Access Compliance Report

Public Rights-of-Way

(Curb Ramps)

Intersection ID: 13197	Main Street: S_MCDOWELL_ST	Cross Street: E_4TH_ST	Location: W
ADA ID: B23154B65FA7	Ramp Type: Perp	Initial Pass/Fail: Pass	Overall Compliance: No
			Severity Score: 5.25
Codes/Mitigation Info/Possible Solution		Field Measurements/Component Compliance

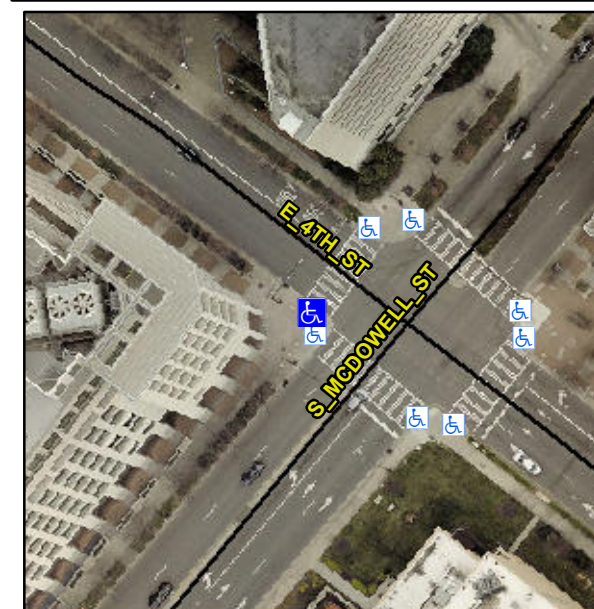
**Not Found, R304.5.3, R304.2.2-Perp,
R304.3.2-Para, R304.5.4**

Compliance	Description	Data	Compliance	Description	Data
N/A	Ramp Length (in)	48.0	Yes	Ramp Slope (%)	6.3
Yes	Ramp Width (in)	48.0	No	Ramp XSlope (%)	4.0
N/A	Flare Type LT	Sloped	N/A	Flare Type RT	N/A
N/A	Flare Slope LT (%)	4.7	Yes	Flare Slope RT (%)	9.9
N/A	Flare Traversable LT?	Yes	N/A	Flare Traversable RT?	Yes
Yes	Landing Length (in)	60.0	Yes	DWS Provided?	Yes
Yes	Landing Width (in)	60.0	Yes	DWS Contrast?	Yes
No	Landing Slope (%)	2.9	Yes	DWS Length (in)	24.0
No	Landing X Slope (%)	3.5	Yes	DWS Full Width?	Yes
N/A	Landing Curb? (Y/N)	No	Yes	DWS Offset (in)	2.0
N/A	Shared Landing?	Yes			
Yes	Gutter Ponding?	No	No	Gutter Slope (%)	5.7
Yes	Gutter Lip Ht (in)	0.0	Yes	Gutter X Slope (%)	2.3
N/A	Painted X Walk1?	Yes	N/A	Painted X Walk2?	N/A
	X Walk 1 Direction	To NE		X Walk 2 Direction	N/A
N/A	X Walk 1 Width (in)	180.0	N/A	X Walk 2 Width (in)	N/A
	X Walk 1 Slope (%)	0.8		X Walk 2 Slope (%)	N/A
	X Walk 1 X Slope (%)	2.8		X Walk 2 X Slope (%)	N/A

**Remove & Replace Entire Ramp.
Remove & Replace Gutter.**
